TITLE 675 FIRE PREVENTION AND BUILDING SAFETY COMMISSION

Final Rule

LSA Document #19-330(F)

Rule 4.4. 2020 Indiana Residential Code

**FIGURE R502.8
CUTTING, NOTCHING, AND DRILLING**

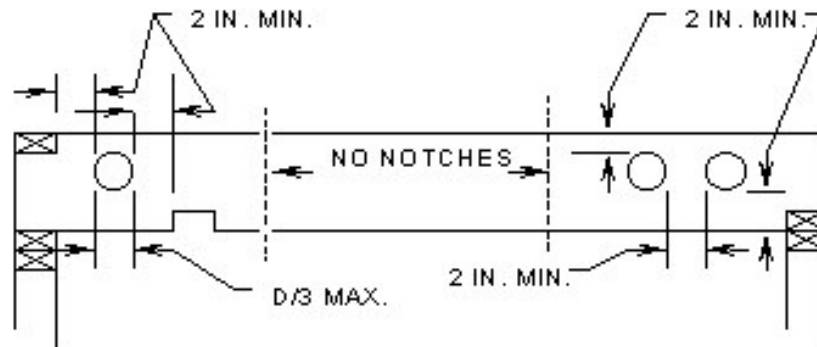
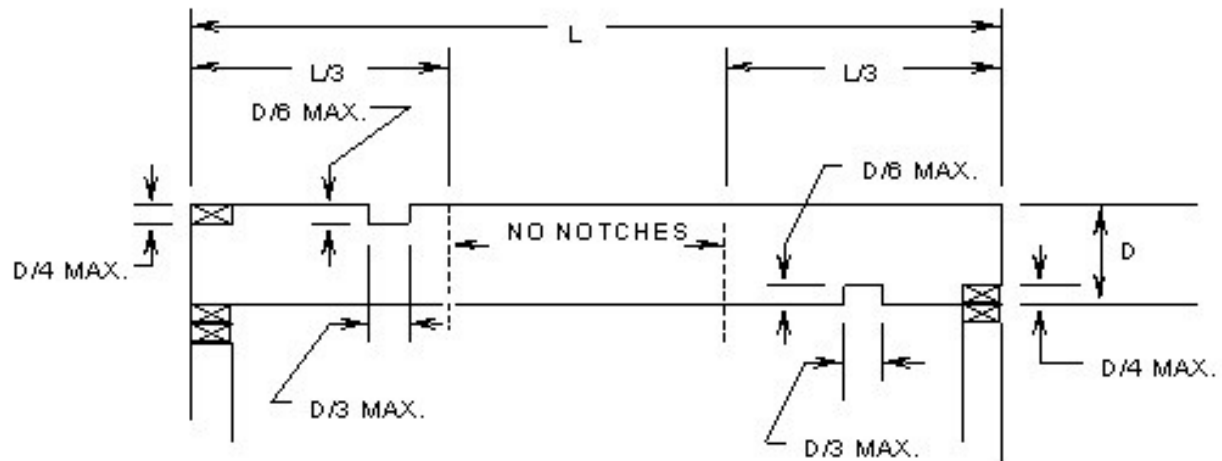
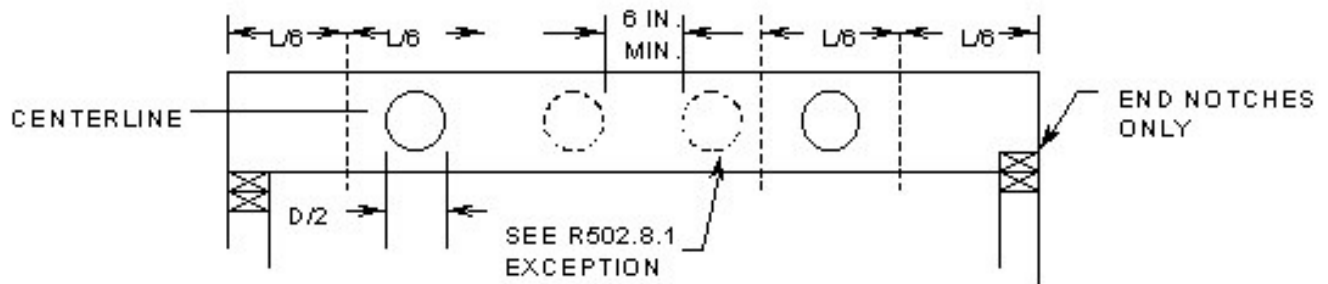
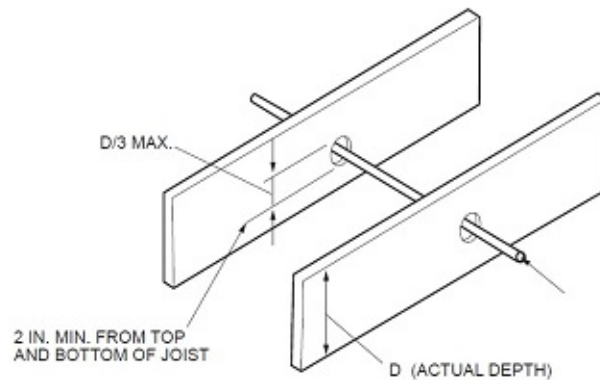
Sec. 59. Delete FIGURE R502.8 and substitute to read as follows: FIGURE R502.8:

FIGURE R703.7.6(1)

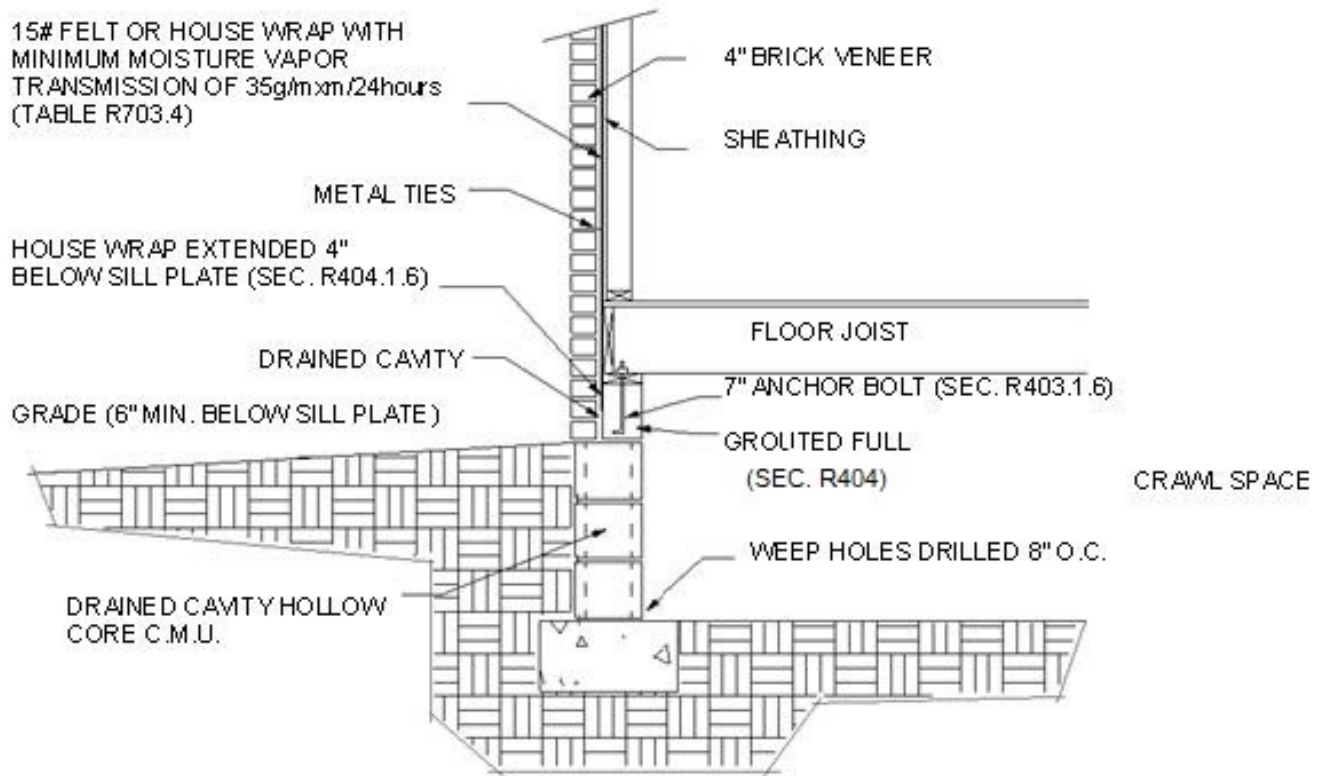
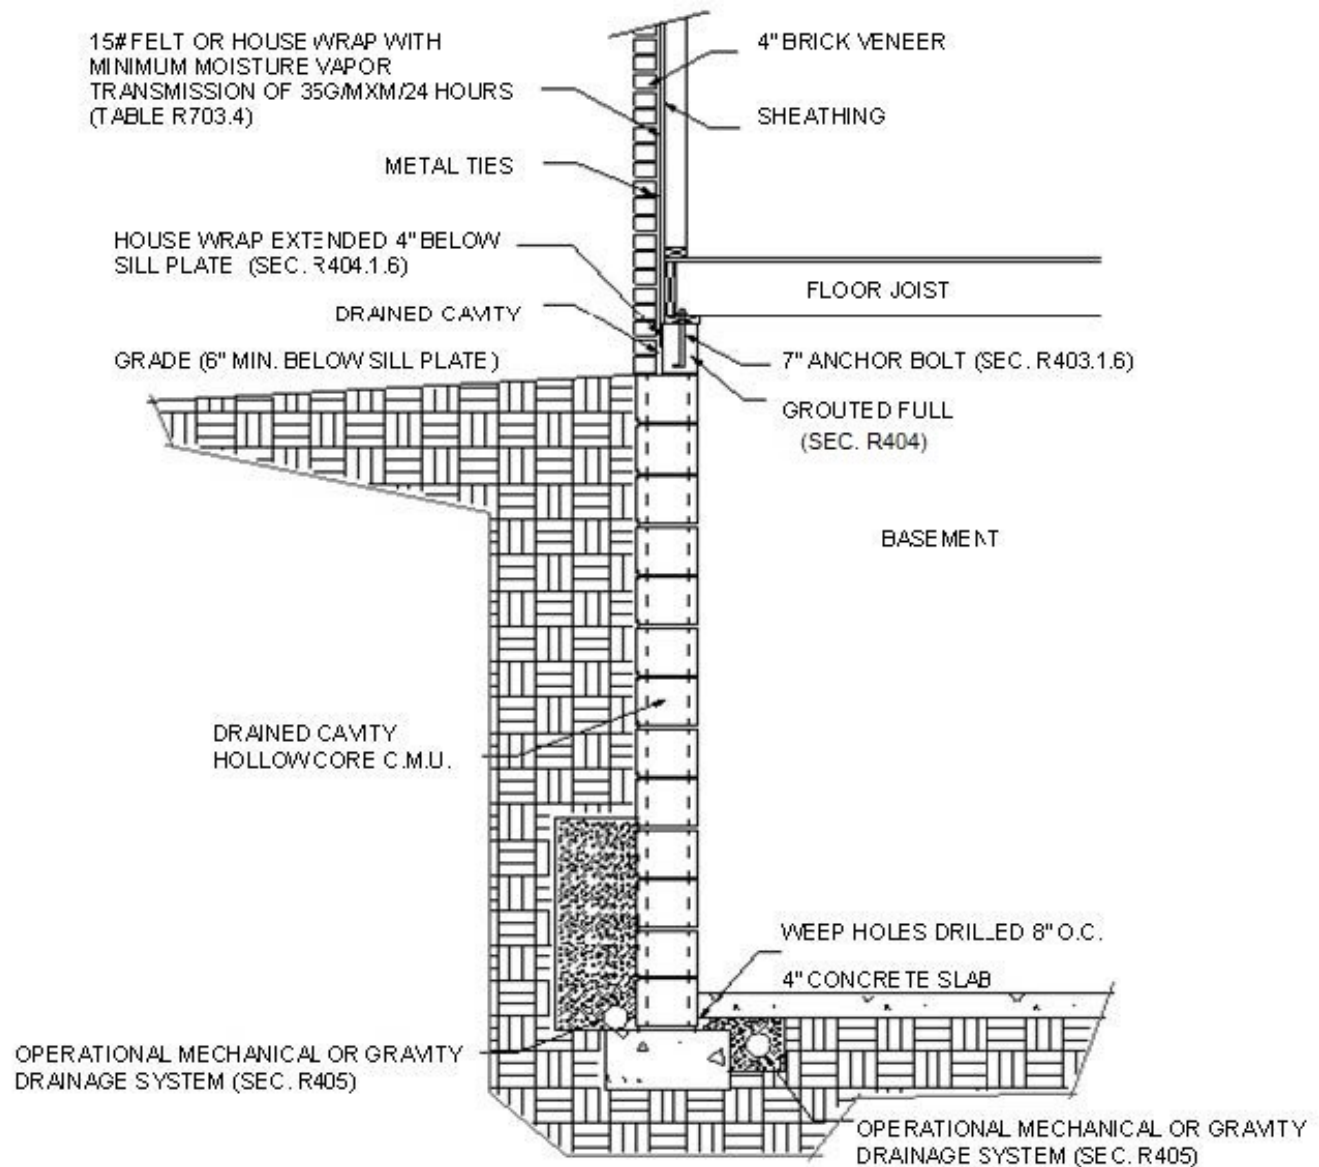
Sec. 79. Delete SECTION R703.8.6 in its entirety and substitute to read as follows:

The 3/4 inch (19 mm) air cavity shall be drained to the exterior of the structure at intervals of not more than 33 inches (838 mm) on center. Each drain shall be not less than 3/16 inch (4.8 mm) in diameter, located immediately above the flashing. For dwellings with crawlspaces, the air cavity may be drained as shown in FIGURE R703.8.6(1). For dwellings with basements, the air cavity may be drained as shown in FIGURE R703.8.6(2).

FIGURE R1003.9 TERMINATION

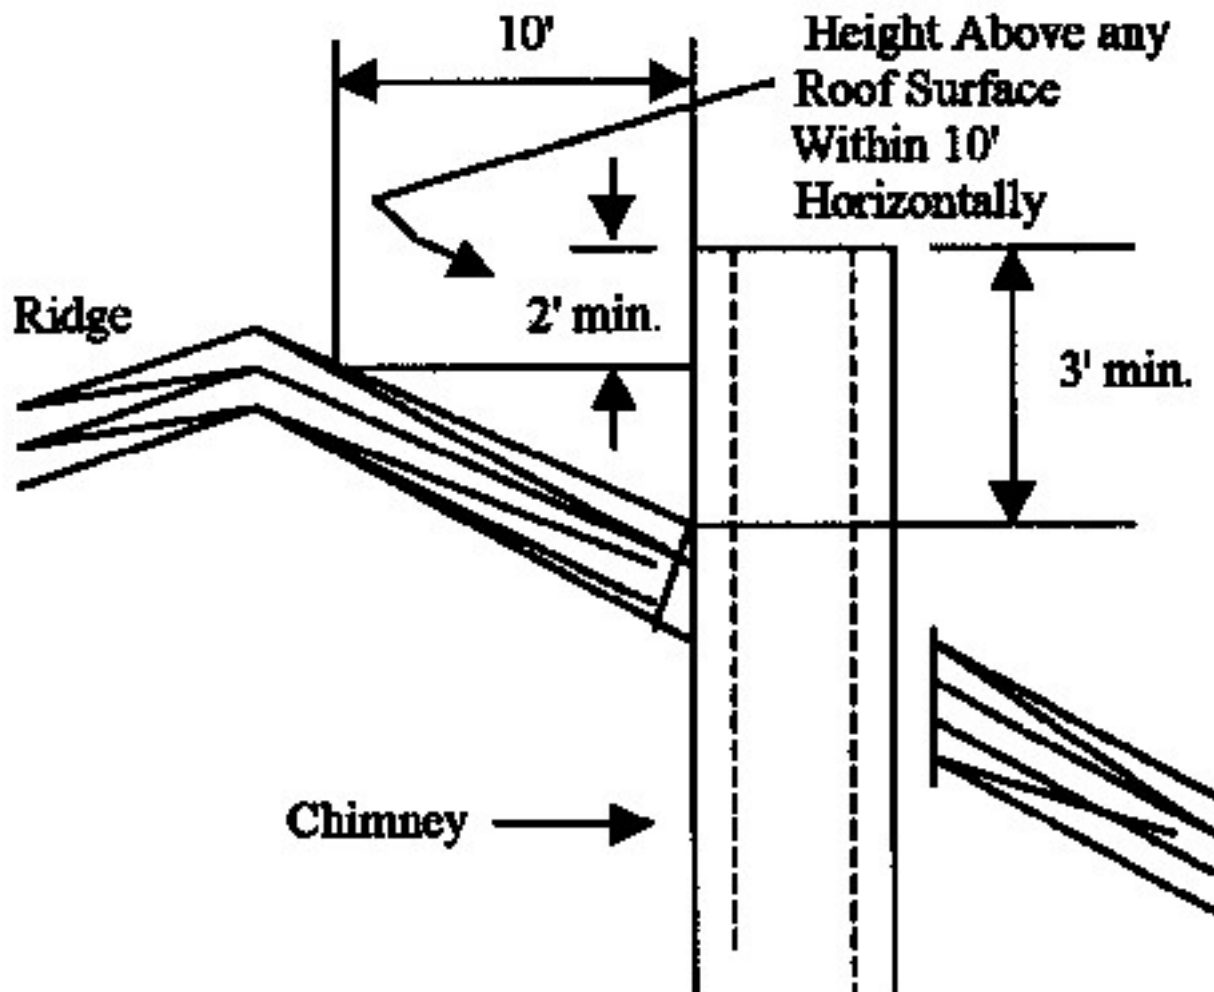
Sec. 88. Add FIGURE R1003.9 after SECTION R1003.9 as follows:
